SAN ANTONIO WATER SYSTEM
San Antonio River Outfall (SARO) Pipeline – Project 2A
Solicitation Number: CO-00070-SM
Job No.: 14-4508

ADDENDUM NO. 1
September 1, 2016

SAWS JOB NO. 14-4508 (SS)
SAN ANTONIO RIVER OUTFALL PIPELINE,
PROJECT NO. 2A
PLAN VIEW
STA. 105+30.74 TO STA. 126+00

SAWS JOB NO. 14-4508 (SS)
SAN ANTONIO RIVER OUTFALL PIPELINE,
PROJECT NO. 2A
PLAN VIEW
STA. 126+00 TO STA. 145+23.17

SAWS JOB NO. 14-4508 (SS)
SAN ANTONIO RIVER OUTFALL PIPELINE,
PROJECT NO. 2A
BYPASS PIPING PLAN
BOBBIE ALLEN WAY

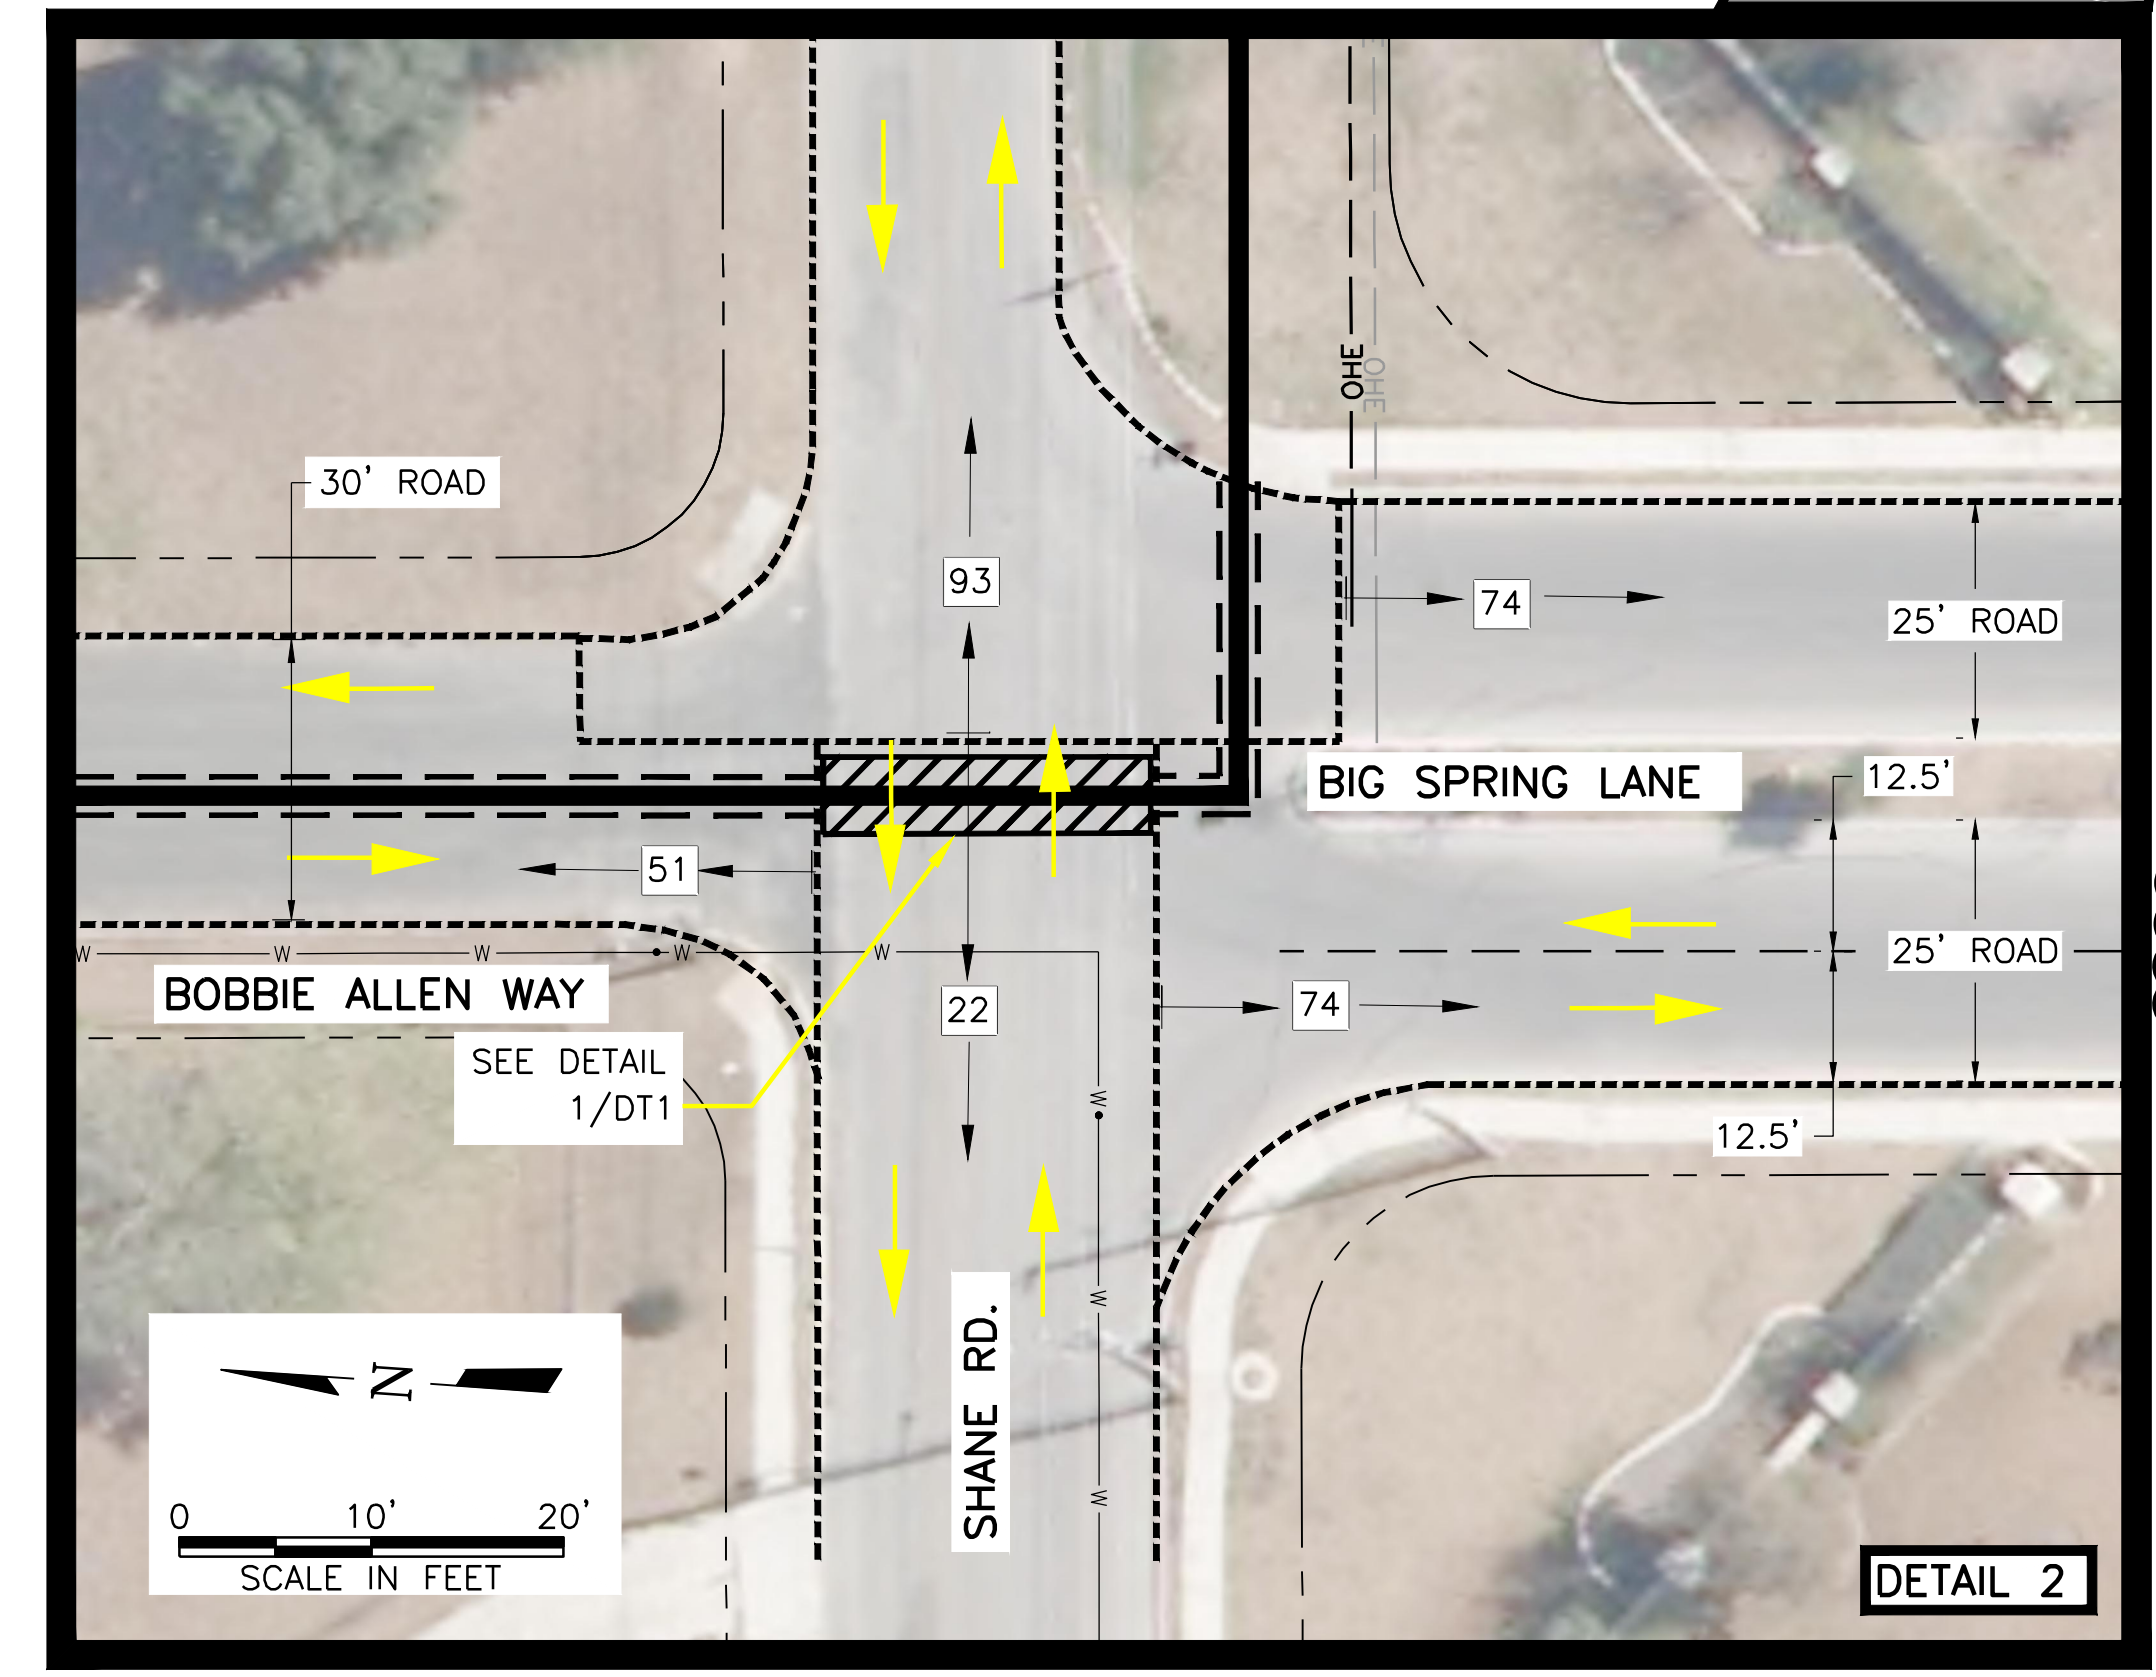
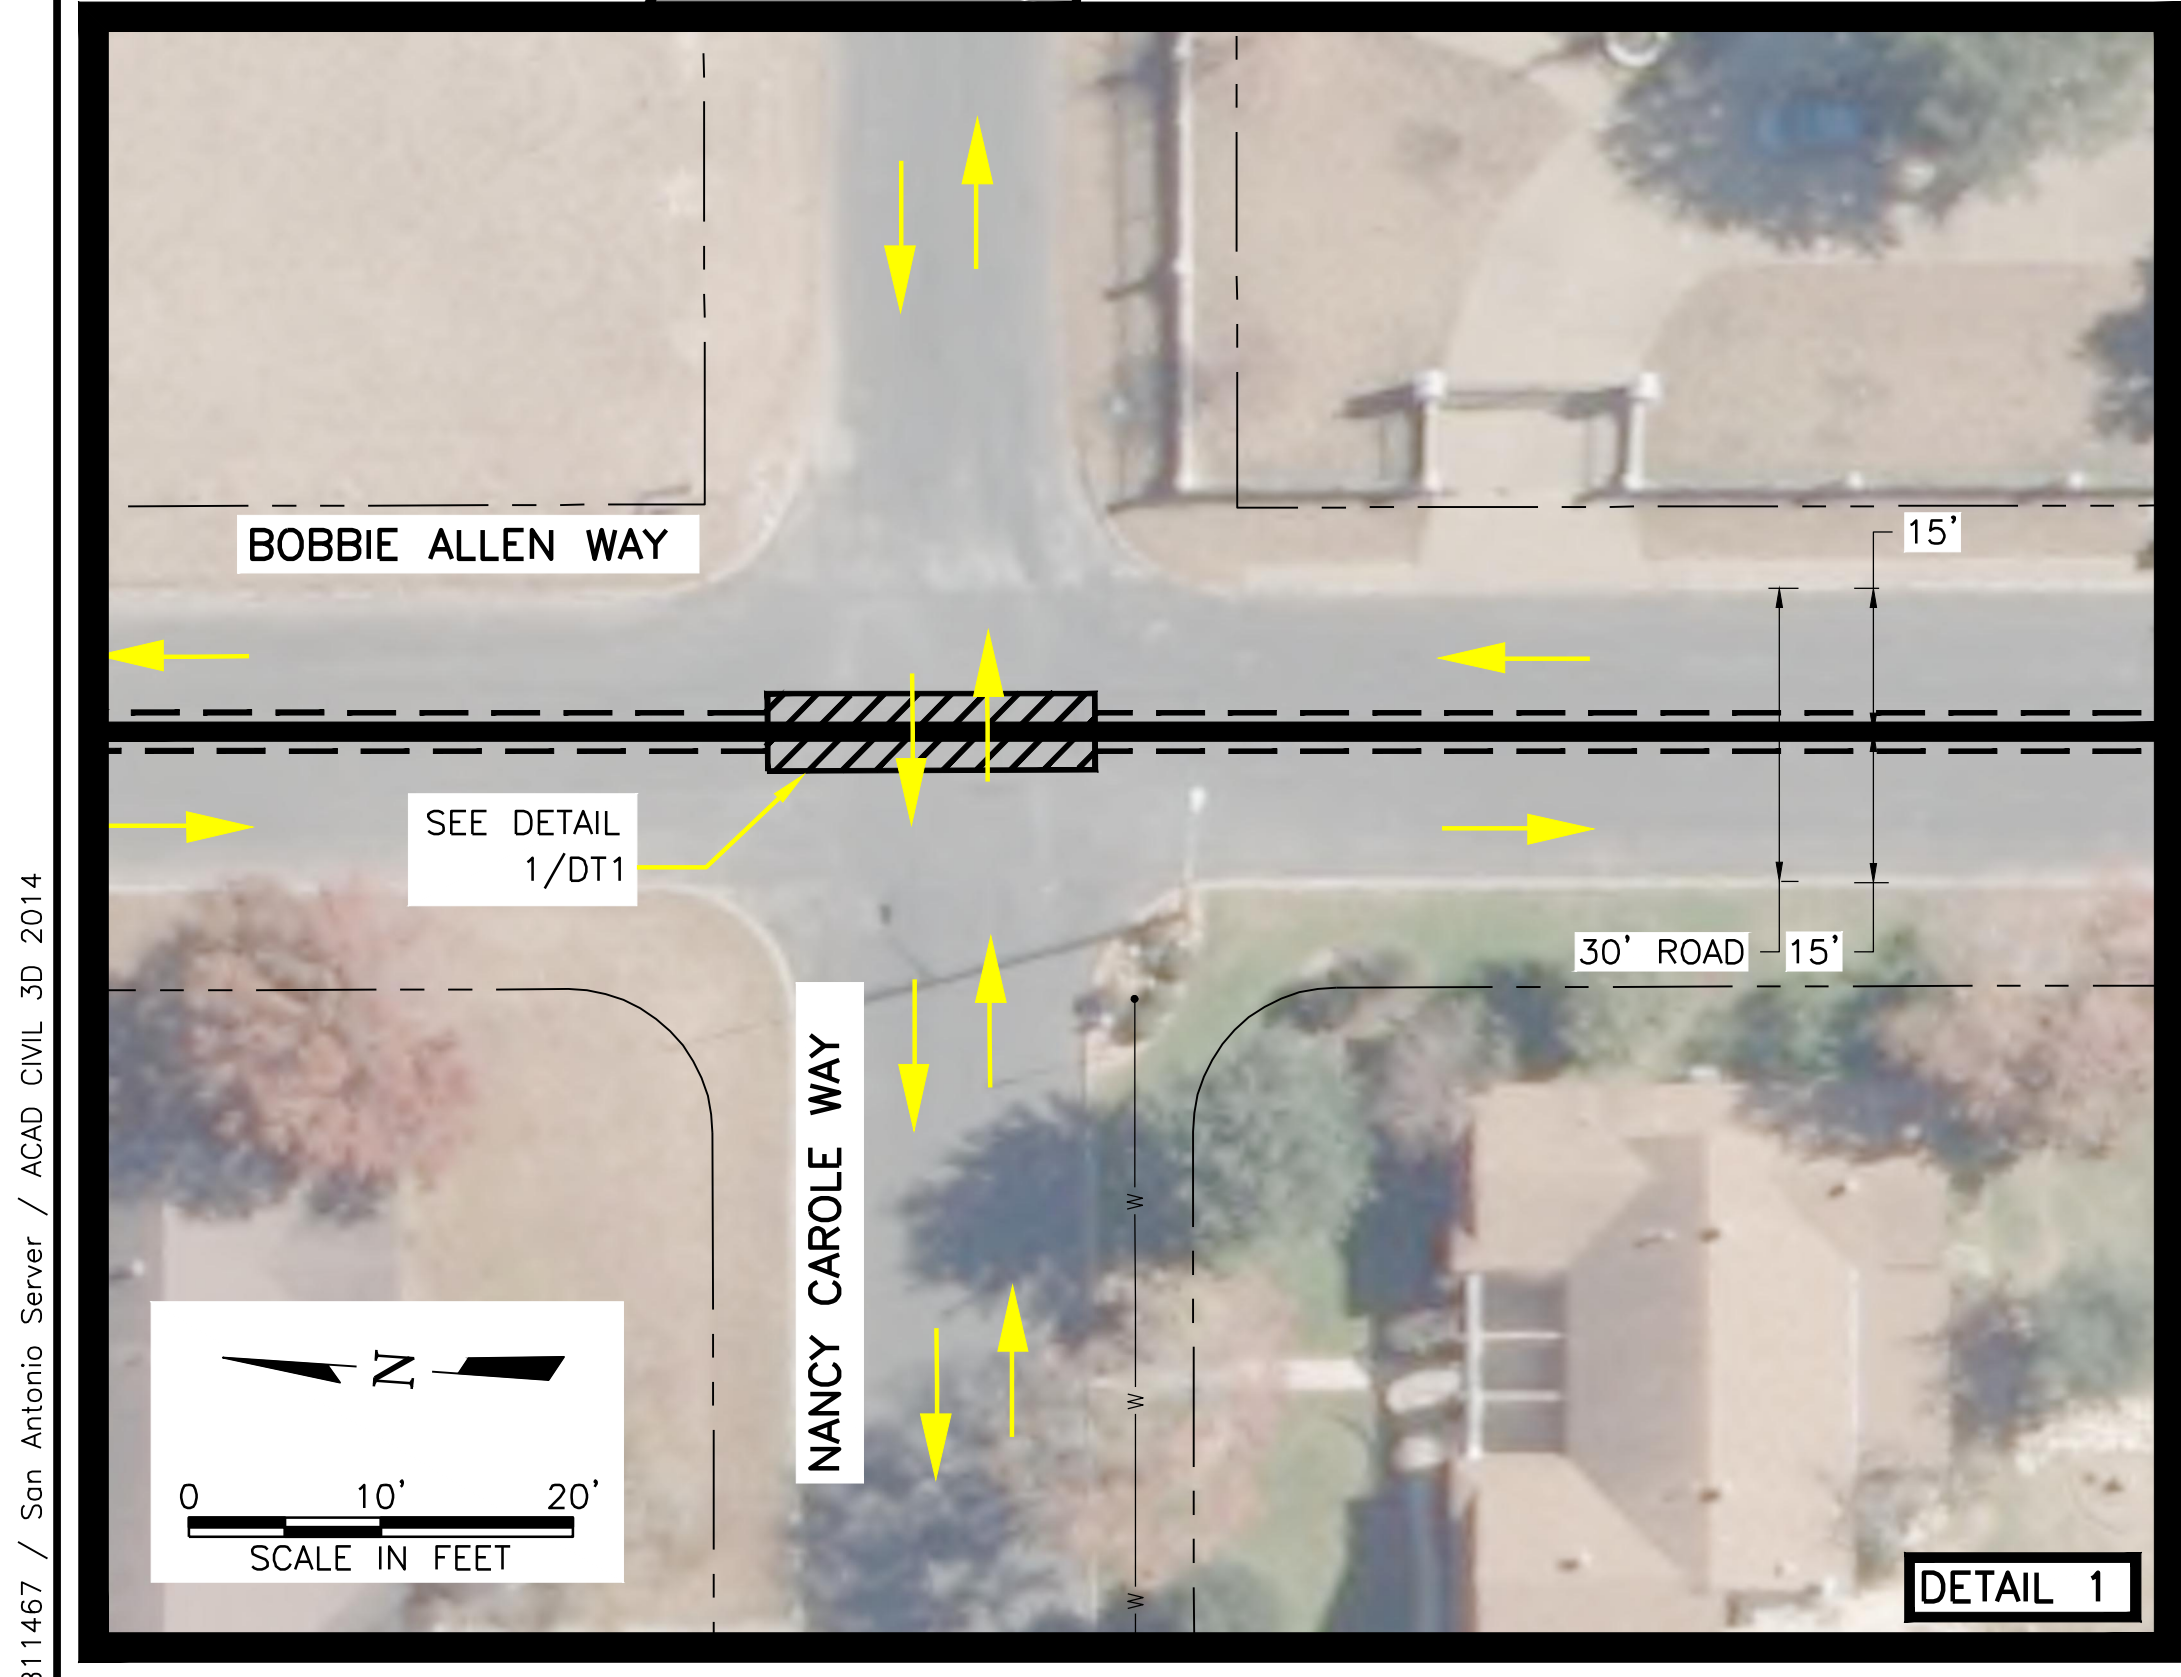
- On BP-2, the PCIs are shown in a square box. Additional PCIs have been incorporated into the revised plan Sheet BP-2 as part of Addendum No. 1*
16. General Conditions pgs. GC-23 and GC-24, Section 5.7. Please clarify that if Insurance Items 1 through 3 are provided (WC, EL and CGL), then Item 4 the OCP will not have to be provided? Does the word “OR” apply to all of the above, or just item 3 only being substituted for the OCP?

- THE FOLLOWING COSA PAVEMENT CONDITION INDEXES (PCIs) SHALL APPLY (SEE DETAIL 2/BP-2 FOR ADDITIONAL INFORMATION):
 - SHANE RD BETWEEN BOBBIE ALLEN WAY AND RICHEY OTIS WAY: PCI = 51-85

- RICHEY OTIS WAY BETWEEN SHANE RD AND LAURA LEE WAY: PCI = 51-85
 - LAURA LEE WAY BETWEEN RICHEY OTIS WAY AND BOBBIE ALLEN WAY: PCI = 51-85
 - BOBBIE ALLEN WAY BETWEEN LAURA LEE WAY AND SHANE RD: PCI = 51-85

- CINDY SUE WAY BETWEEN RICHEY OTIS WAY AND BOBBIE ALLEN WAY: PCI = 51-85
 - NANCY CAROLE WAY BETWEEN RICHEY OTIS AWY AND BOBBIE ALLEN WAY: PCI= 51-85
 - BEXAR COUNTY ROADS DO NOT HAVE PCIs ASSOCIATED WITH THEM.
